UNIT 2 TECHNICAL SPECIFICATION

LIST OF EFFECTIVE PAGES

DRAFT

Figure 3.1-1

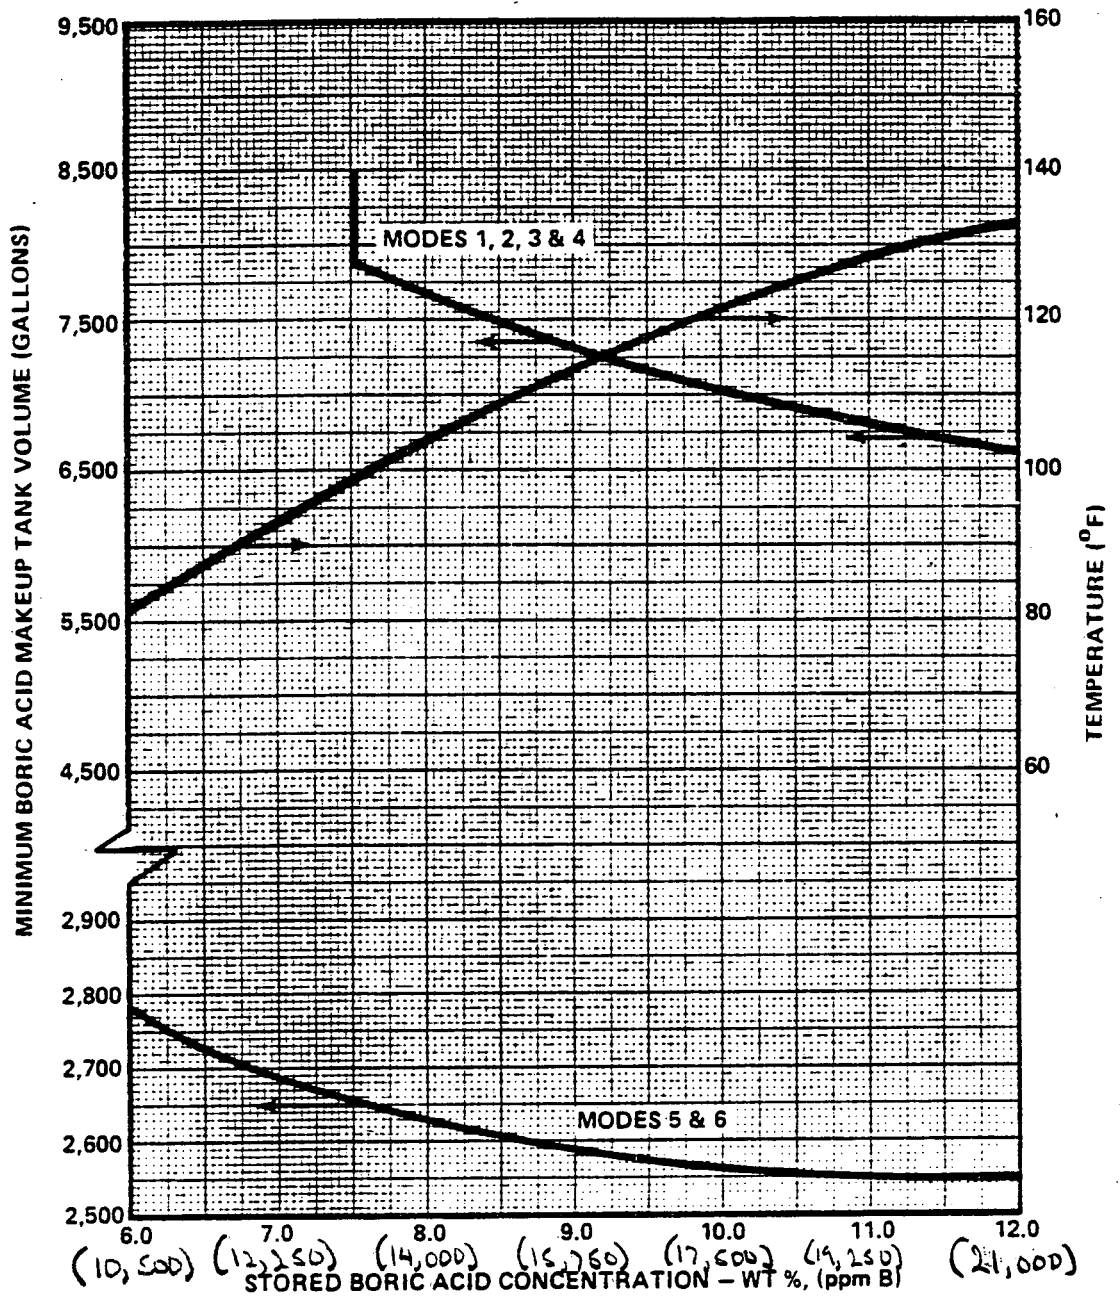
- a. At least one and at least one associated heat tracing circuit boric acid makeup tank with the contents of the tanks in accordance with Figure 3.1-1, and X
- b. The refueling water storage tank with:
1. A ~~minimum~~ contained borated water volume of between (later) and (later) ~~355,000~~ gallons, X
 2. Between 1720 and 2300 ppm of boron, and ~~and~~
 3. A minimum solution temperature of ~~35°F~~ 40 X

Figure 3.3-1

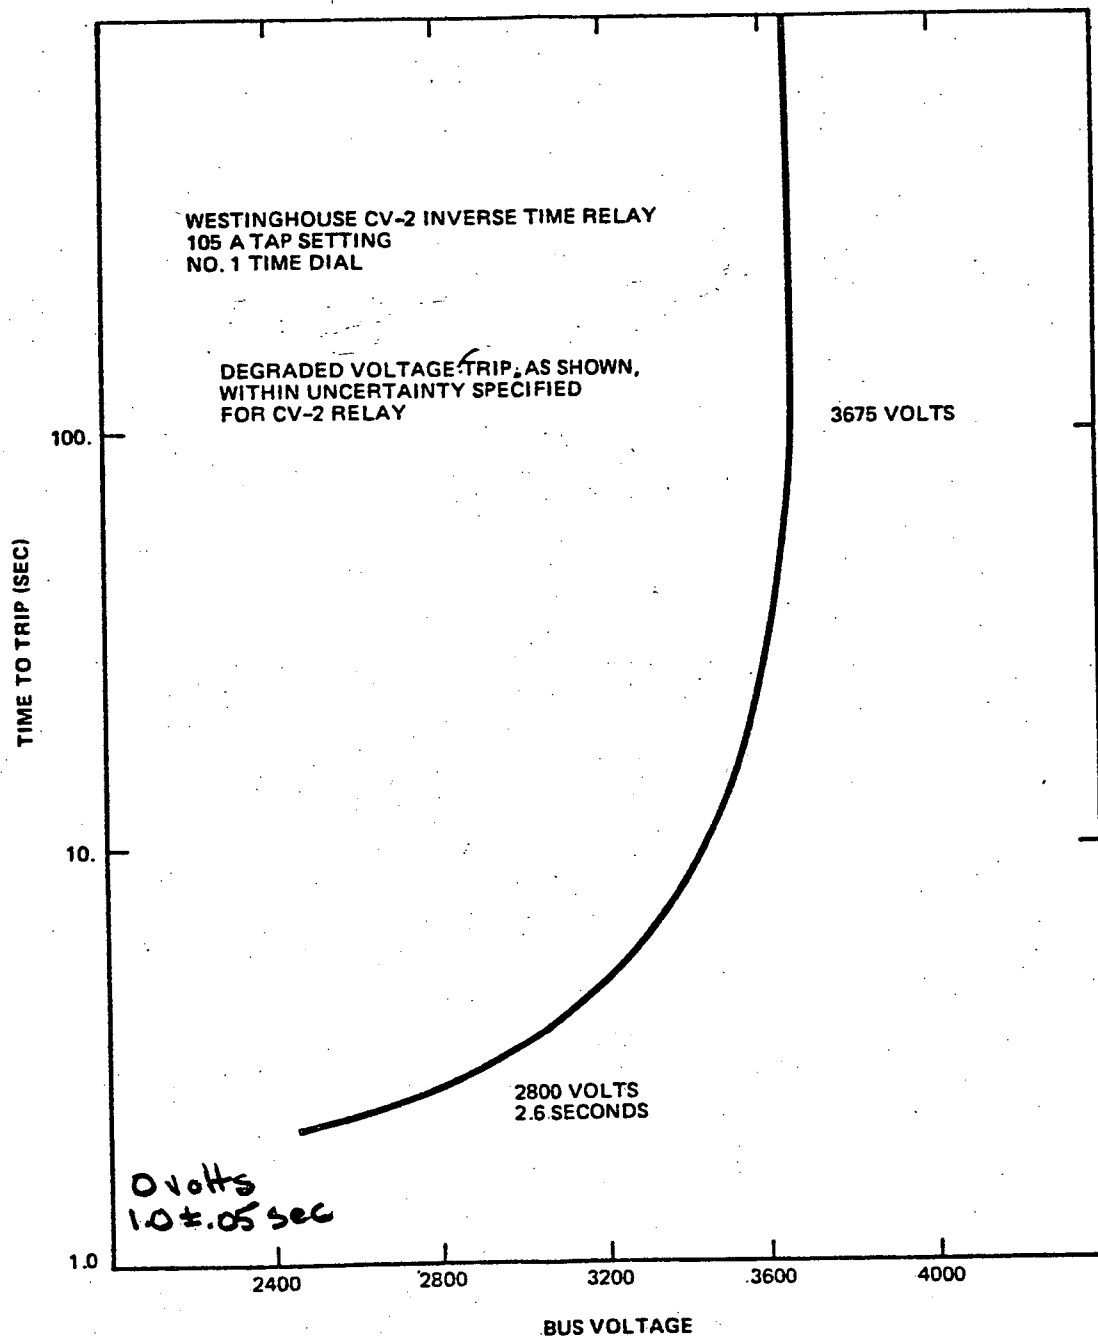
anal. SAR
Self-Test
PIS

3.12-1
 FIGURE 3.18.1 TERRESTRIAL MONITORING FOR THE
 RADIOLOGICAL ENVIRONMENTAL
 MONITORING PROGRAM

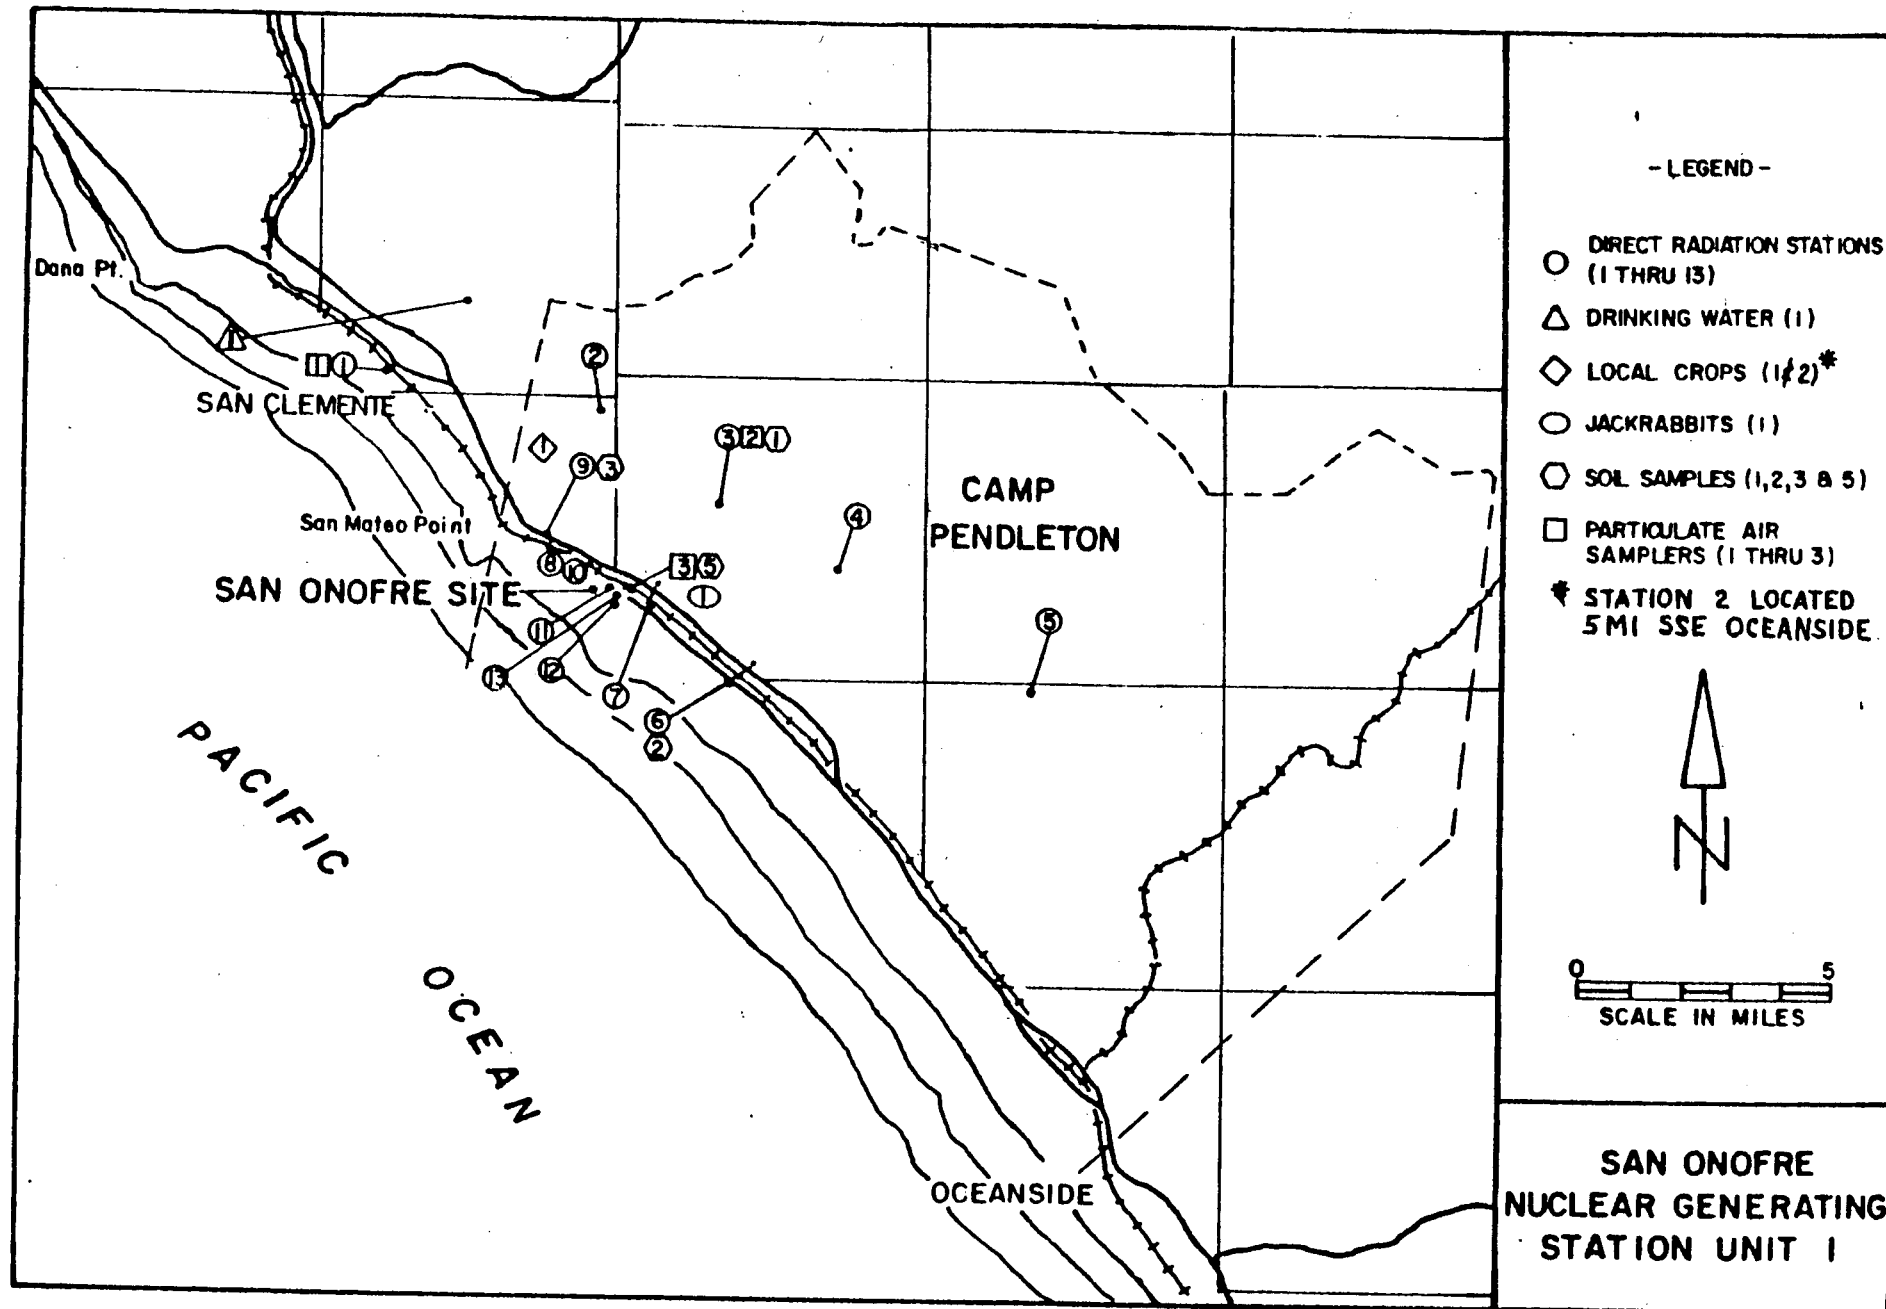
(1) See Figure ~~3.10.1~~ 3.12-1

(2) See Figure ~~3.10.2~~ 3.12-2
